Overlay Field Application Program Implementation Site Visit Report On Pennsylvania SR-119, SR-1032 and Mon-Fayette (43)

FEBRUARY 25, 2009

Pennsylvania Department of Transportation

Figure 3 Existing Typical Section

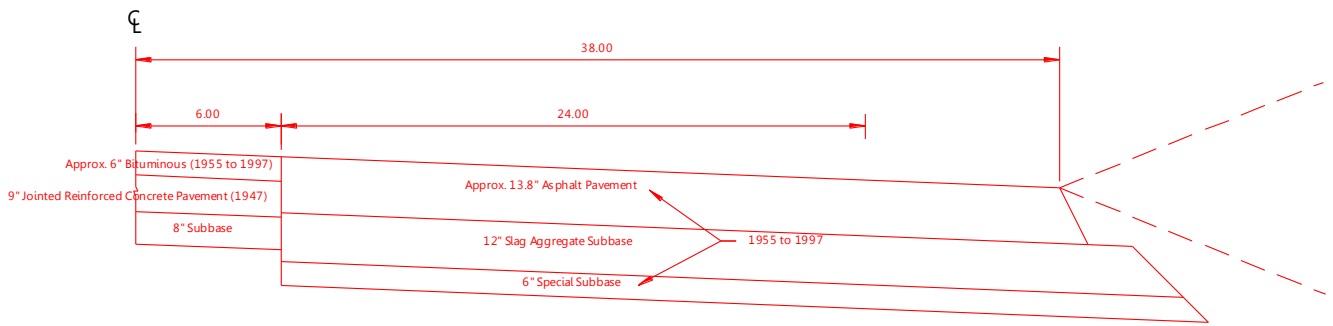
Information provided by PennDOT in conjunction with observations made during the site visit provides the basis for the assumed existing typical section. Descriptions of the original construction and maintenance history suggest that there may be considerable variability in the existing pavement section throughout the length of the project. This section of roadway was originally constructed in 1947 and 1955 as a two lane facility and later widened and overlaid to its current state as a five lane roadway. Cores taken 18' right and left of centerline show an average asphalt thickness of 13.8". Figure 3 is a sketch of the typical section based on historical information and discussions during the site visit. Actual conditions across the entire width and length of the roadway should be verified through additional core samples (discussed in detail later).

1. Perform additional site investigations to confirm that the existing typical section is consistent with historical records.
 - a. Core the existing pavement and shoulders to determine the condition of the materials, depth of any distress, moisture condition underneath the concrete pavement and to verify the thicknesses of layers. Cores should be taken at approximately 1,000' intervals (each direction) spread across both lanes and shoulders, at areas representative of typical distresses and at longitudinal joints. Cores should also be located in areas which will characterize the different phases of construction.

Figure 8 Typical Section 6" Bonded Concrete Overlay

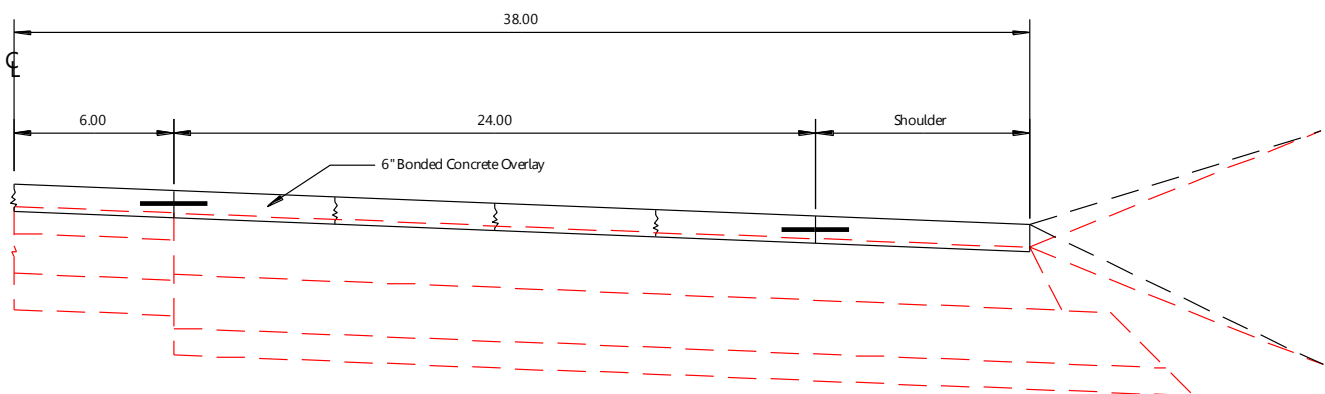
- a. Assume a 6" thick bonded overlay (Figures 8 and 9), it is not the intent of this report to influence PennDOT's pavement design procedures, a thinner overlay may be the solution that best meets PennDOT's objectives for rehabilitating this roadway. Details of a thinner or thicker overlay can be provided at the time PennDOT arrives at a final design thickness. Probable alternative overlay thicknesses may range from approximately 4" up to 7", depending upon the desired life of the overlay.

Figure 17 Typical Distress (loss of support and spalling) Southbound Lane

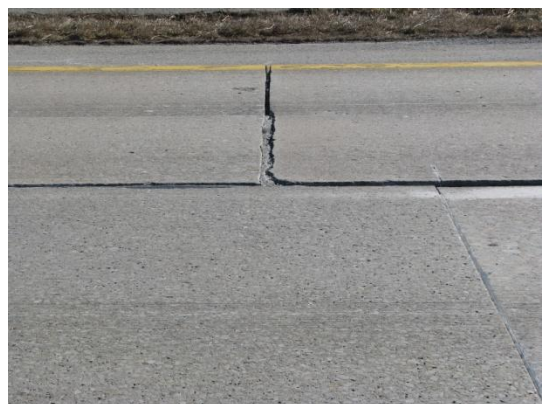
The Everson section of SR-119 consists of a 9" jointed reinforced concrete pavement on a 6" subbase constructed in 1966. Diamond grinding and CPR were performed on both lanes in 1992 and an asphalt overlay was placed on the northbound lanes in 2003. This project is an ideal candidate for an unbonded overlay, for the following reasons:

- The existing asphalt overlay on the northbound lanes can be utilized as a separation layer
- Overhead clearance and lateral transition issues are minimal
- The long slab lengths in the southbound lanes are not conducive to a bonded overlay

A separation layer would need to be placed on the southbound lanes, since they have not been overlaid with asphalt yet. Concrete overlay thickness will be a function of the anticipated traffic, desired pavement life and budget constraints. Michigan's experience with thinner unbonded overlays (4" to 6") is applicable for this project.
